## **PART B – CITY OF WANNEROO**

**Part B – Item 3.1 – LOT 9028 (100K) CONSTELLATION  
ENTRANCE, TWO ROCKS – PROPOSED SERVICE STATION**

**Form 1 – Responsible Authority Report  
(Regulation 12)**

1 7 ELEVEN - SITE PLAN  
 1:200

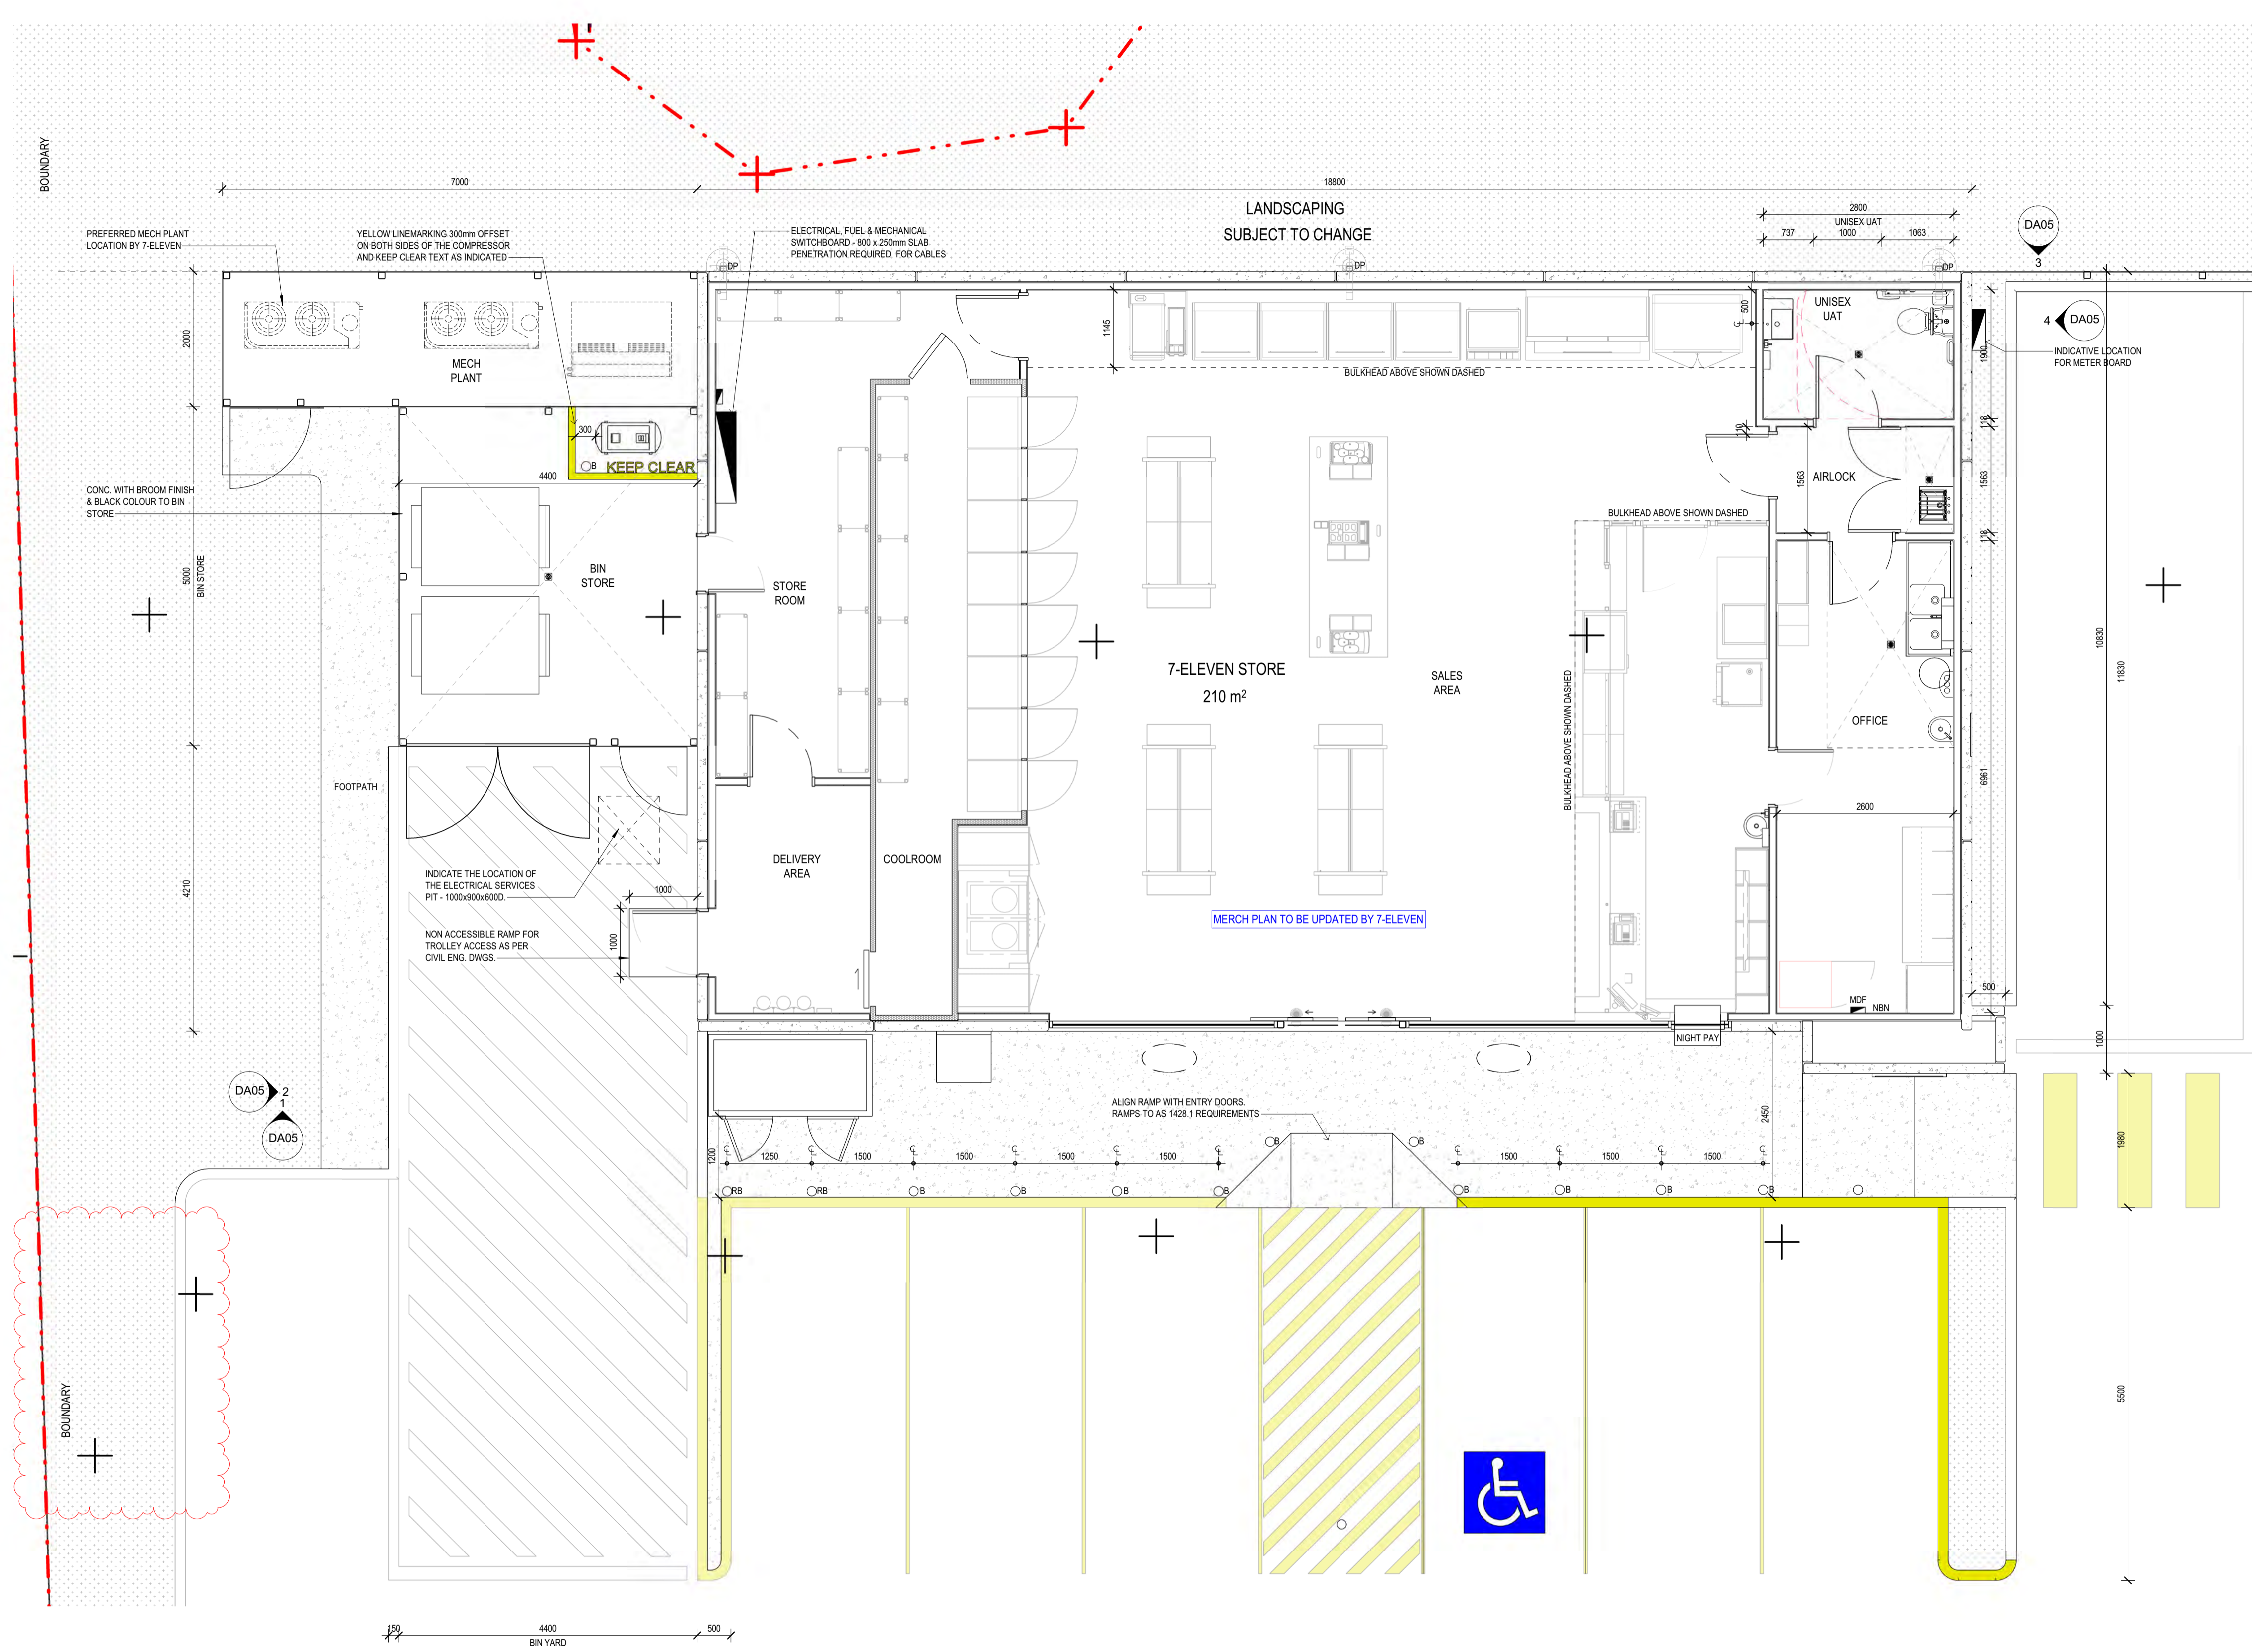
6. Refer to Drawing # DA02, the proposed<sup>OFFICIAL</sup> Pylon sign located to the south of the crossover to/from Dunraven Road should not obstruct drivers' visibility in term of pedestrian safety.
7. Main Roads' Driveways policy states that 'driveways should be as near to 90 degrees to the road centreline as conditions will permit'. It is recommended that the left-out driveway to Breakwater Drive meet this requirement (70 degrees absolute minimum).
